From: Tom Vander Woude, Planning Director

Re: **DEVELOPMENT PLAN APPROVAL**

PC Docket No. 19-007 Ted Vinyard requesting approval of a development plan for the remodeling of the Dairy Queen restaurant at 830 Ridge Road.

EXISTING SITE PLAN

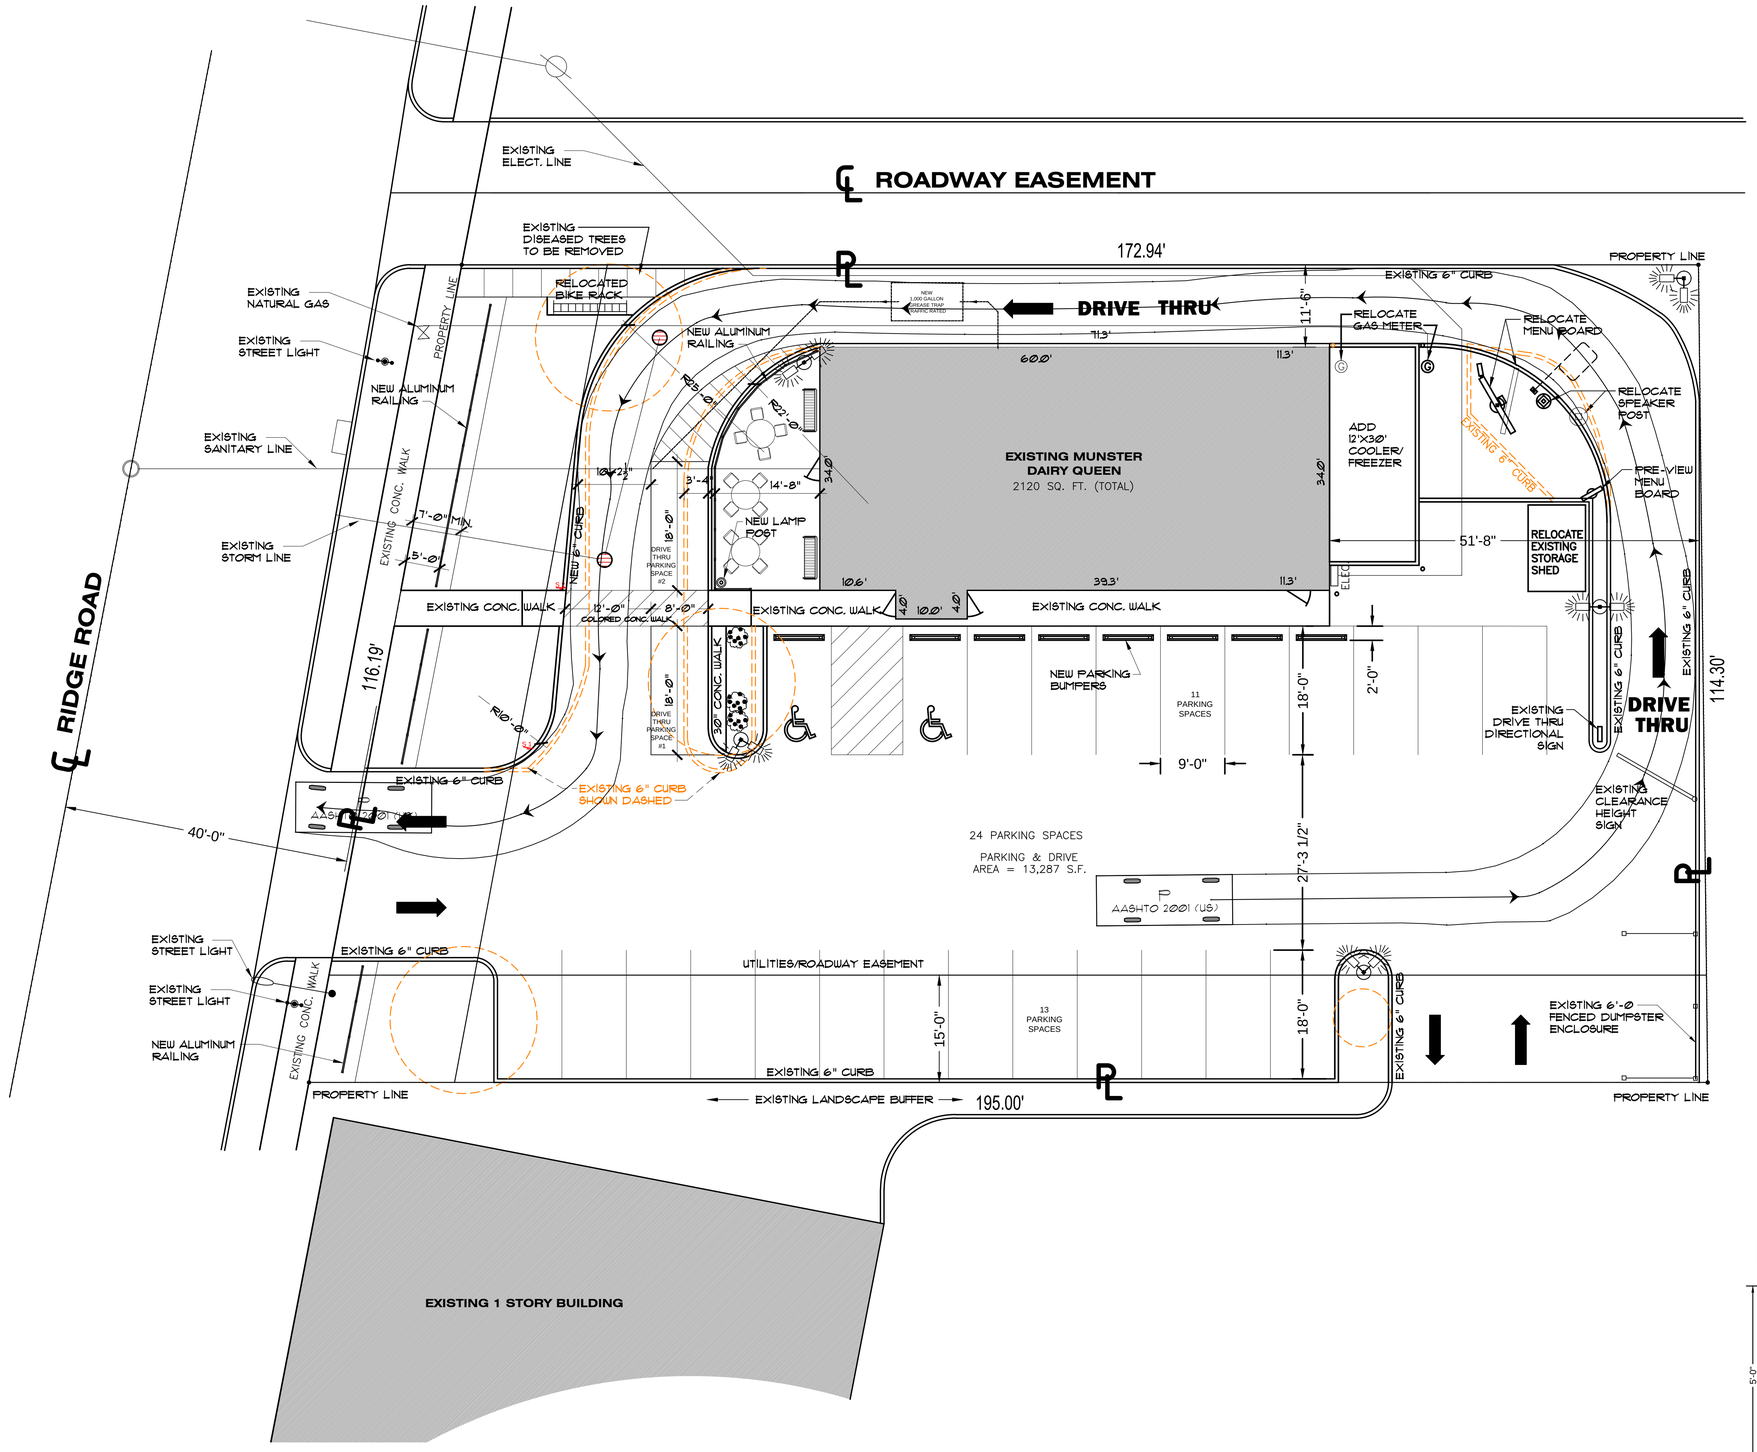
<u>Site Plan</u>
The primary change to the site plan is the widening of the drive through aisle to include two temporary parking spaces, where vehicles can wait to receive their orders. This results in a slightly smaller patio area and landscape setback.

Based on the second calculation, the property requires 29 spaces. The lot currently contains 22 parking spaces; the petitioners plan to increase the total parking to 26. The proposal is decreasing the legal nonconformity.

Two additional temporary parking spaces are proposed to be located in the front of the building where vehicles can wait to receive their orders. It should be noted that the restaurant currently reserves two spaces along the west edge of the parking lot for this use.

Pedestrian Access
A sidewalk is provided on the north side connecting to the existing sidewalk on Ridge Road. The section that passes through the drive through aisle is proposed to be stained concrete.

Stormwater
The drainage and grading plans have been reviewed by the Town Engineer and have been found to be satisfactory for the purposes of stormwater. Impervious surface is proposed to be increased slightly from 18,525.29 square feet to 18,604.13 square feet.

LANDSCAPE PLAN

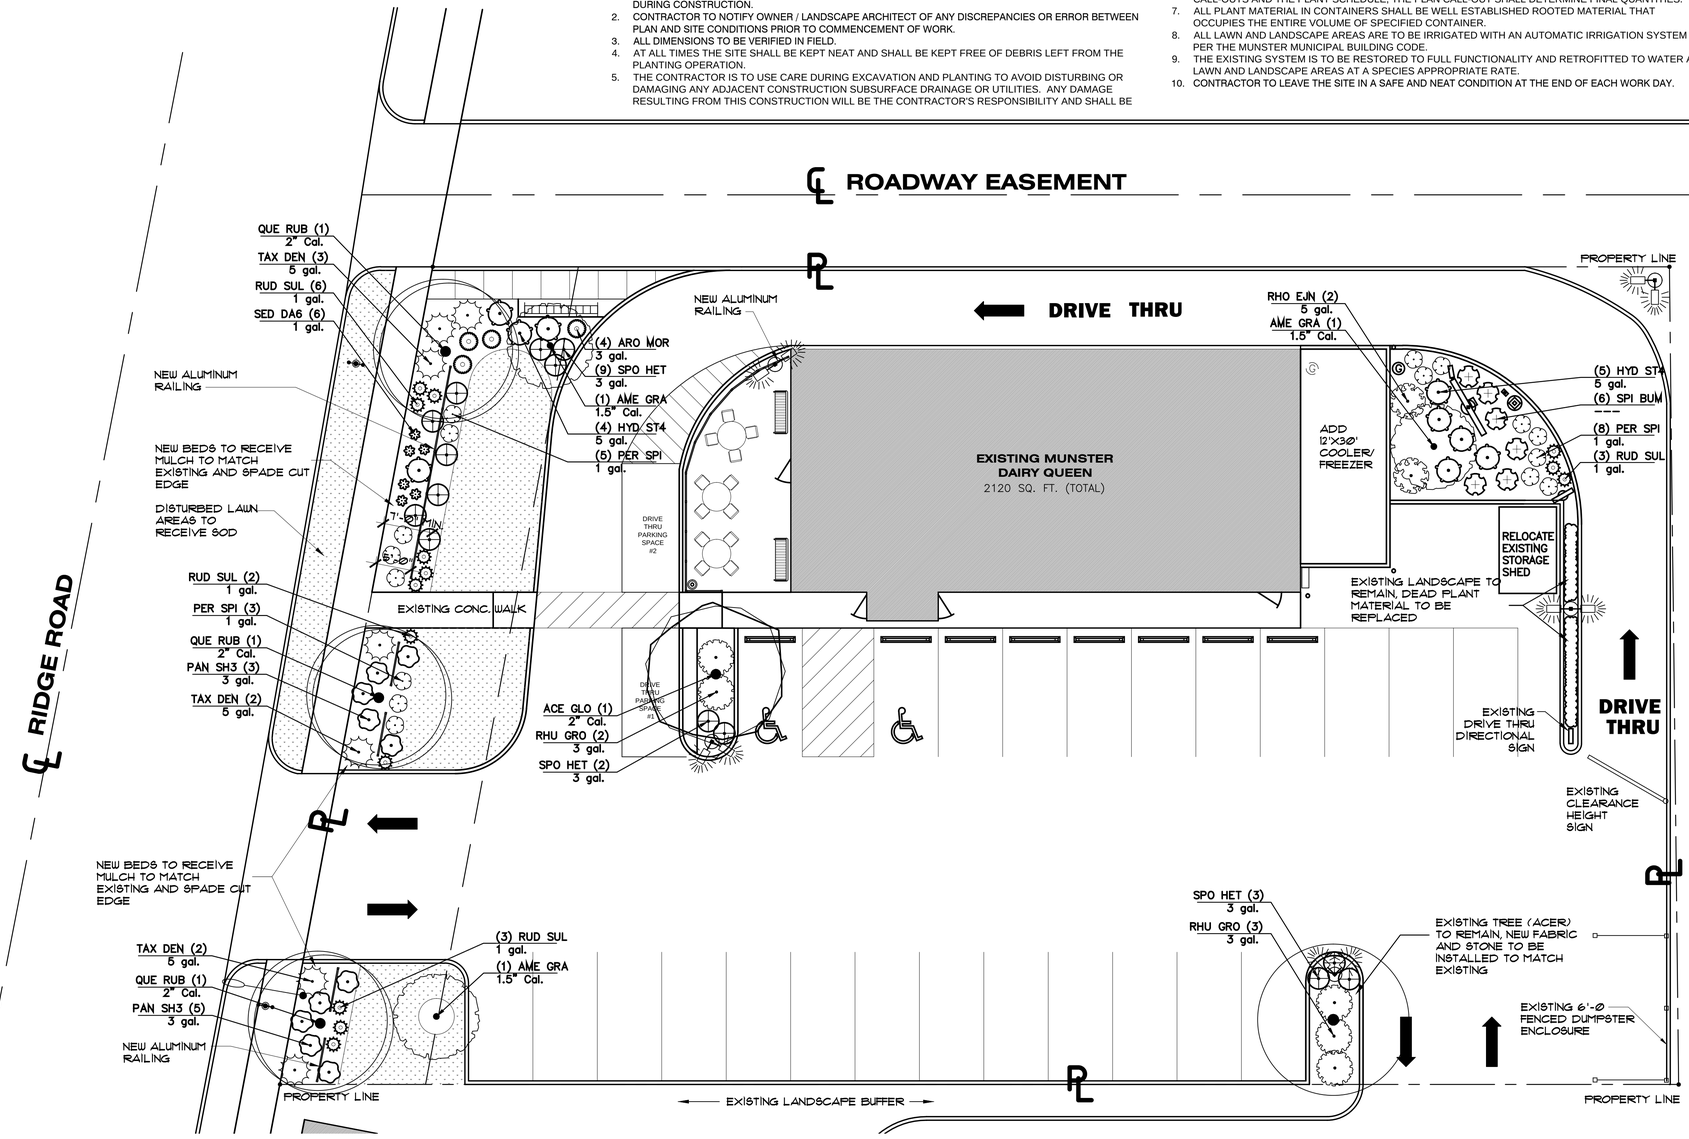
Landscaping
The attached landscaping plan includes enhanced landscaping throughout the site. A seven-foot landscaped buffer with an ornamental fence will be installed along the public right-of-way. The existing parking lot islands and the area around the menu boards will be redesigned and replanted.

The petitioner is seeking landscaping variances from the Board of Zoning Appeals.

CODE STANDARD	REQUIRED	PROPOSED
Parking lot between 4,500 AND 30,000 SF: internal landscape area equal to 7.5% of total	997 SF of internal landscape area	708 SF of internal landscape area
One tree per 125 square feet of required internal landscaped area, exclusive of tree planting required in perimeter landscape area.	11 trees	8 trees
Perimeter landscaped area	7 feet	None on east, west, and south sides.
